Access Compliance Report

Public Rights-of-Way

(Curb Ramps)

Intersection ID: 10018981	Main Street: DEVONGATE_LN	Cross Street: N/A	Location: SE
ADA ID: C132FFBDB957	Ramp Type: BlendTrans1	Initial Pass/Fail: Pass	Overall Compliance: No
		Severity Score: 7.5

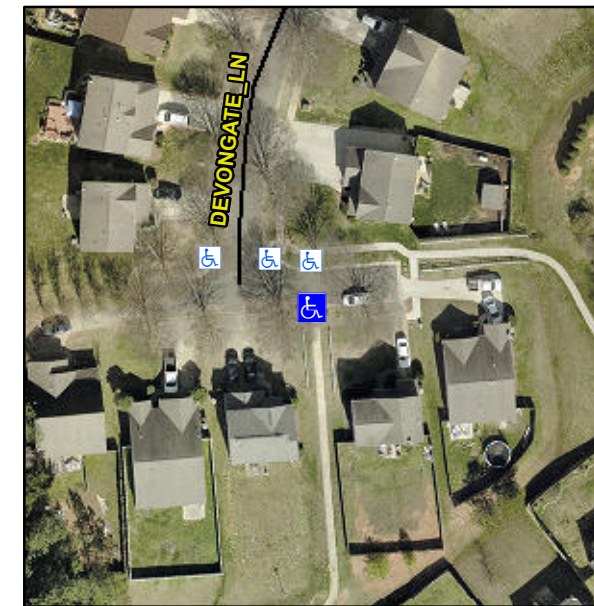
Remove & Replace Landing. Grind Gutter Lip.

R304.2.2-Perp, R304.3.2-Para, R304.5.3, R302.7, R302.7.2
